IOWA DEPARTMENT OF TRANSPORTATION

TO OFFICE: District 3 **DATE:** August 10, 2015
ATTENTION: Tony Lazarowicz **REF. :** Buena Vista County
-FROM: Kevin K. Patel BRF-003-2(65)--38-11
Pin: 13-11-003-020
OFFICE: Design
SUBJECT: Field Exam (D2)

A field exam was held on Thursday, July 16 2015, to review the proposed plan for replacing a bridge over the North Raccoon River, 2.5 miles east of U.S. 71.

IA 3 Bridge over the North Raccoon River, 2.5 miles east of U.S. 71

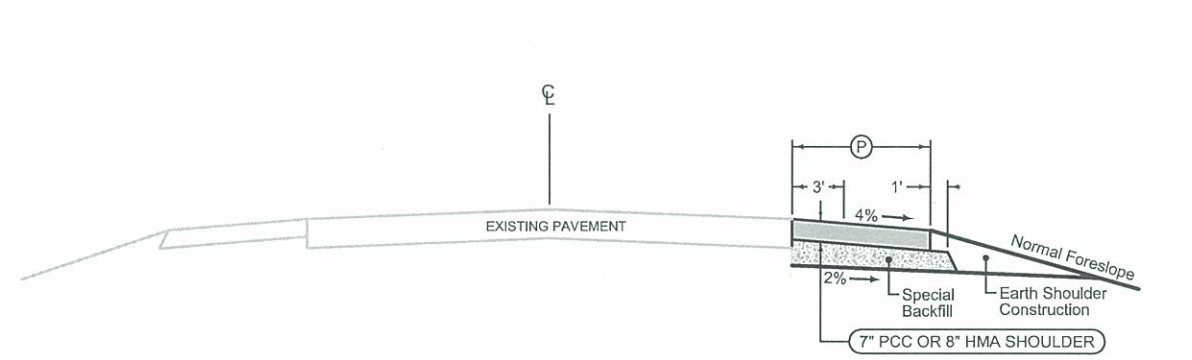
2. Remove ~~shoulder strengthening~~ when project is completed?
Detour pavement

No, leave in place

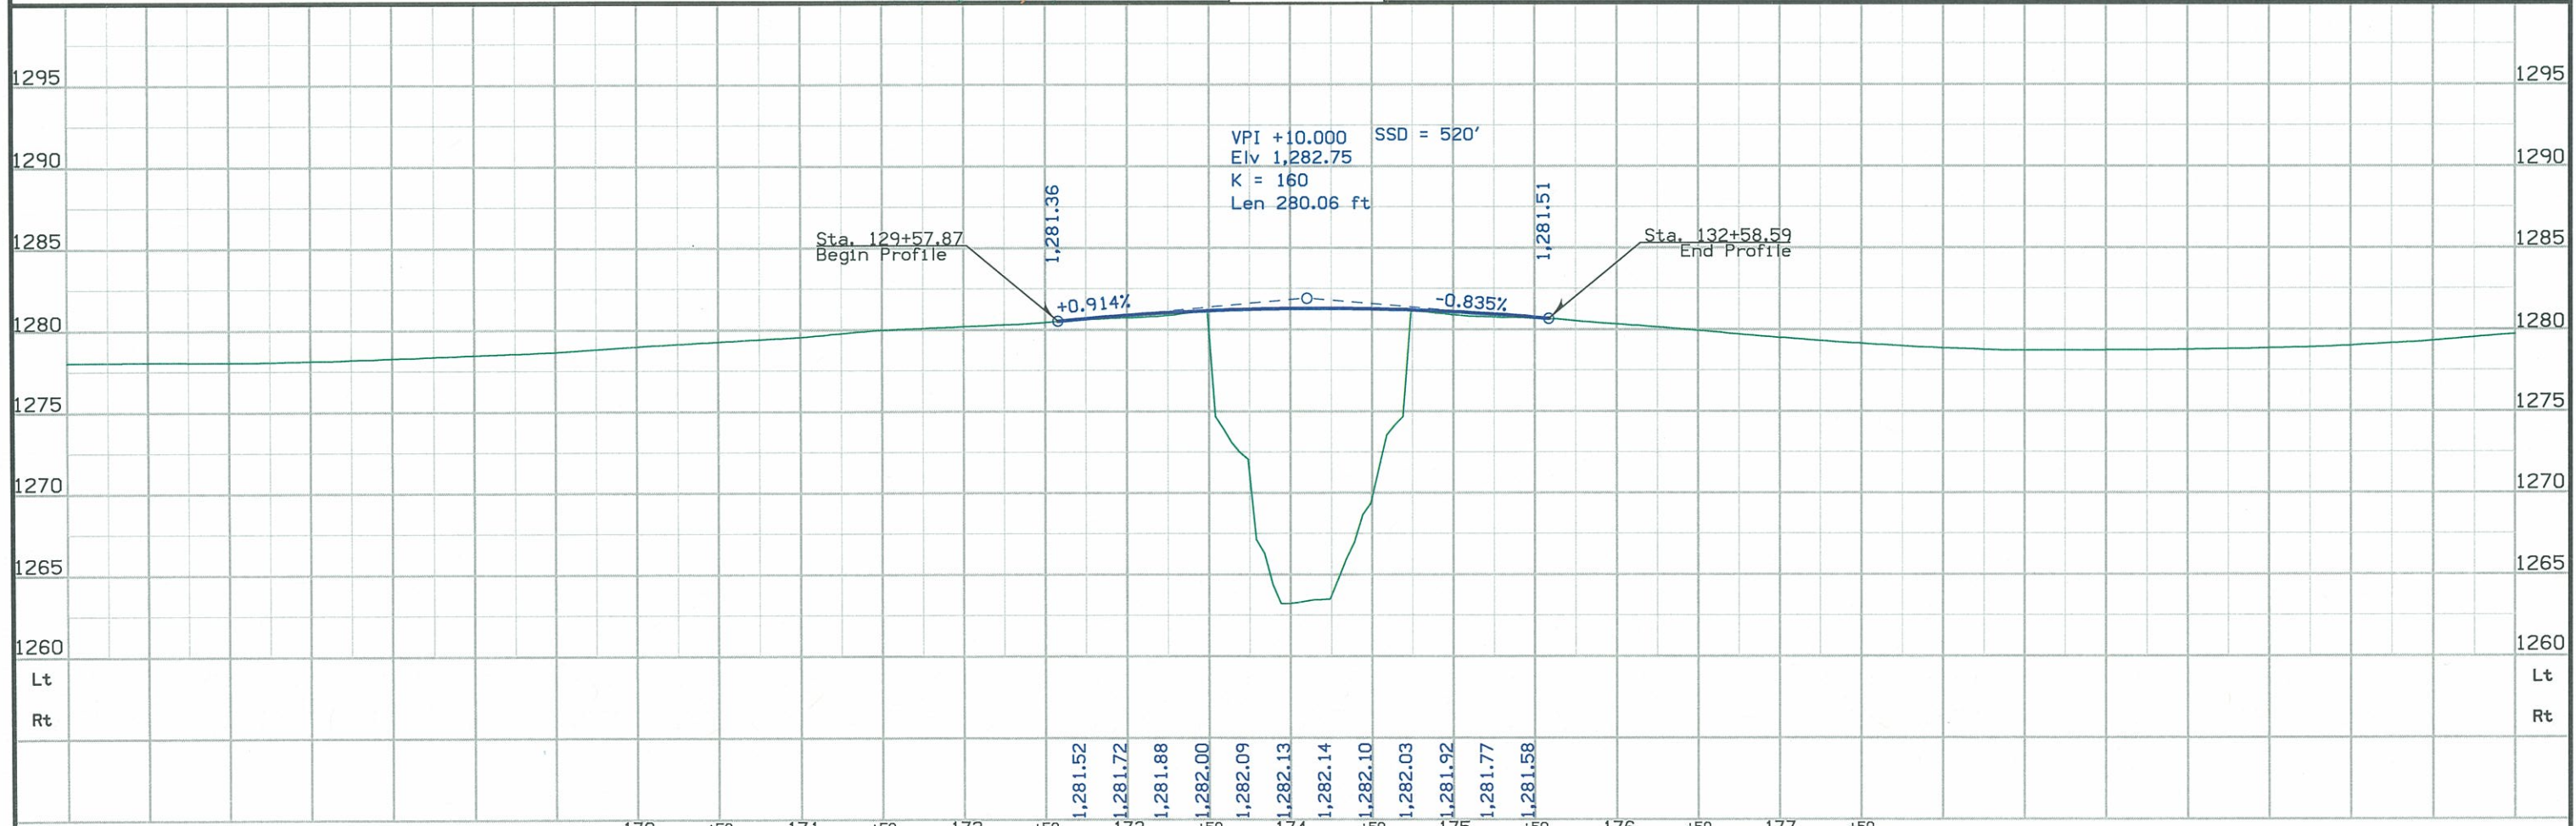
Wetland area
try to minimize impacts

30" pipe not shown

District to review condition of
existing pipes to determine replacement

As per the 8/4/15 note from Tony L.
pipes should be replaced

LONGITUDINAL SECTION ALONG ℄ ROADWAY

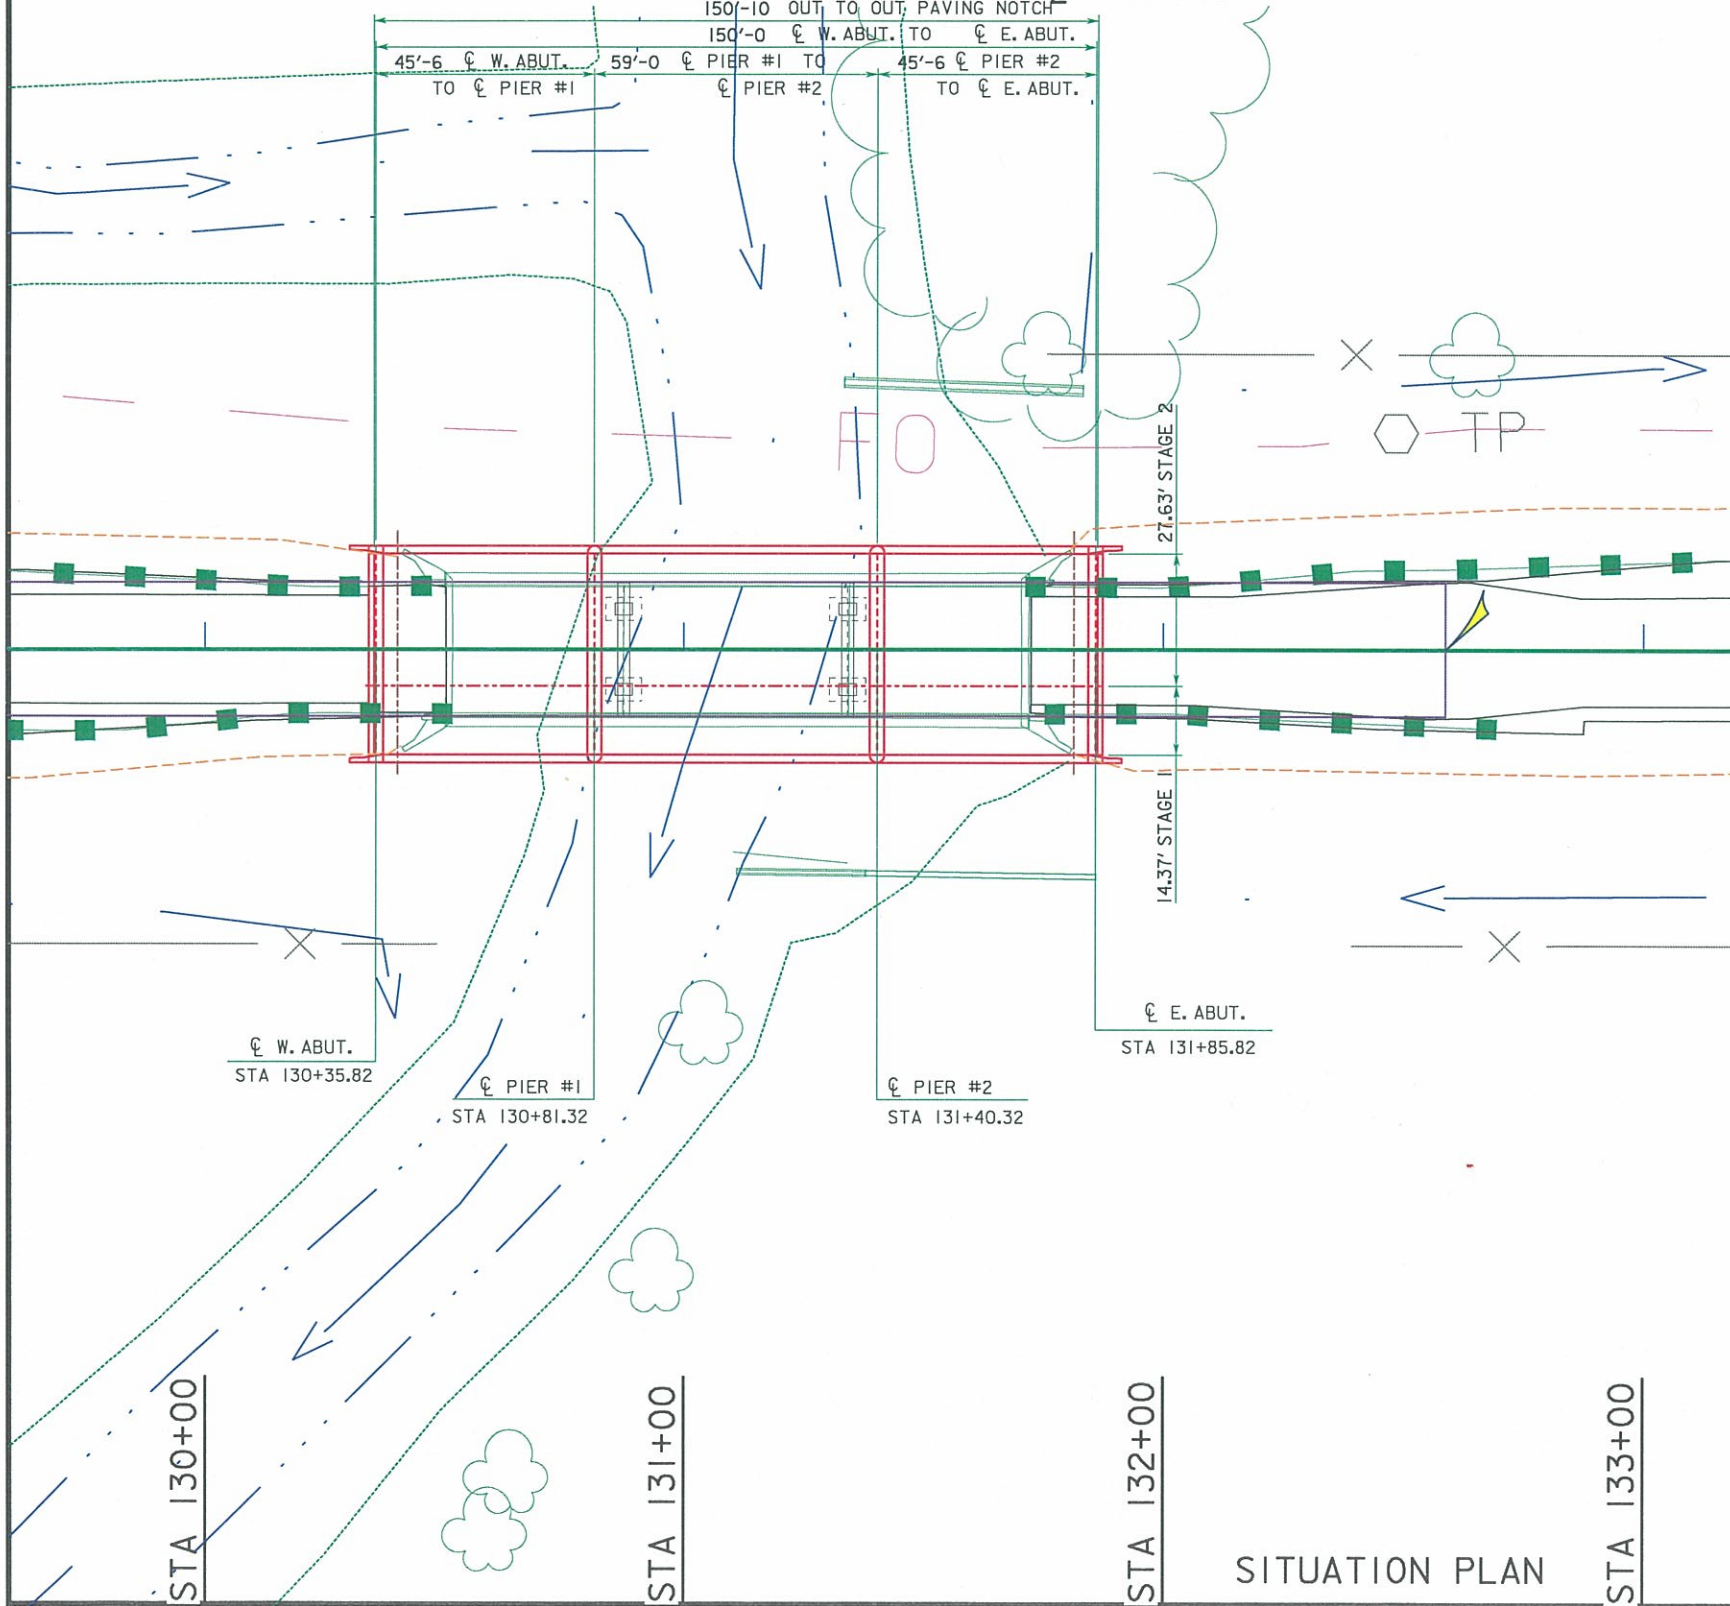
1290	℄ W. ABUT. ELEV. 1281.91	℄ PIER #1 ELEV. 1282.07	℄ PIER #2 ELEV. 1282.09	℄ E. ABUT. ELEV. 1281.96	1290
1280					1280
1270					1270
1260	BERM ELEV.=1277.80				1260
1250	MATCH SLOPE				1250
1240	DESIGN PIERS SO EXISTING PIERS ARE NOT IMPACTED IN FIRST STAGE.				1240
